# Vibration or Rattle Noise From Right-hand Engine Mount

## Applicability

YEAR(S)	MODEL(S)	ADDITIONAL INFORMATION
2020 - 2024	Corolla	VDS(s): B4MCE, B4MDE, B4MEE, M4MCE, M4RCE, P4MCE, P4RCE, S4MCE, S4RCE, T4MCE, T4RCE Engine(s): M20

### REVISION NOTICE

**Figure 1.**

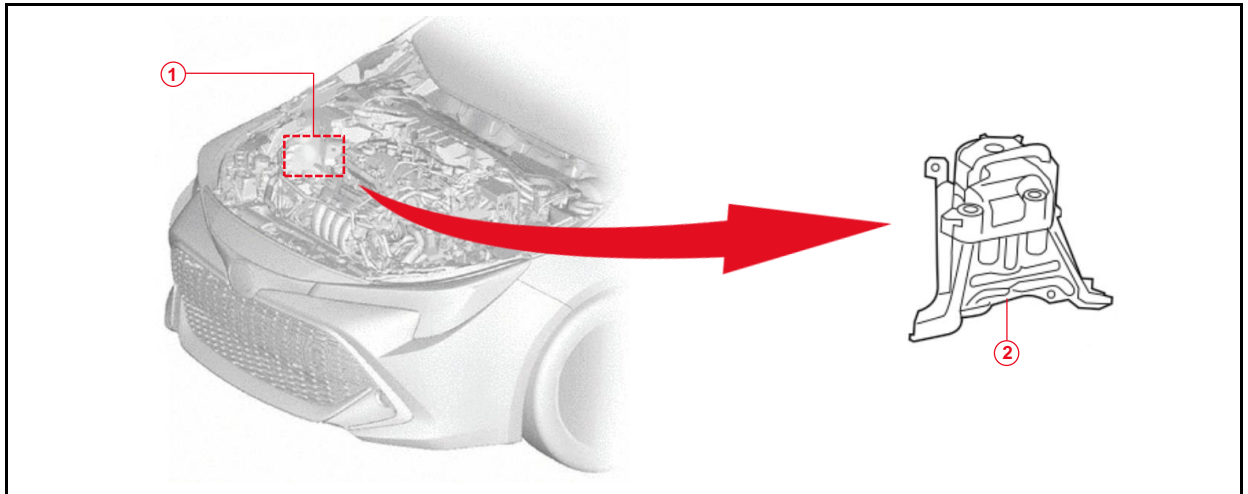
Some 2020 – 2024 model year Corolla vehicles may exhibit a vibration or rattle noise from the right-hand engine mounting insulator sub-assembly. This condition will usually go away when the engine Revolutions Per Minute (RPM) are above idle. This condition is typically found on vehicles in warm climates/weather. No Diagnostic Trouble Codes (DTCs) are associated with this condition. Follow the Repair Procedure in this bulletin to improve this condition.

2. Locate the right-hand engine mounting insulator sub-assembly.

4. Install the NEW right-hand engine mounting insulator sub-assembly with the part number provided in the Parts Information table.
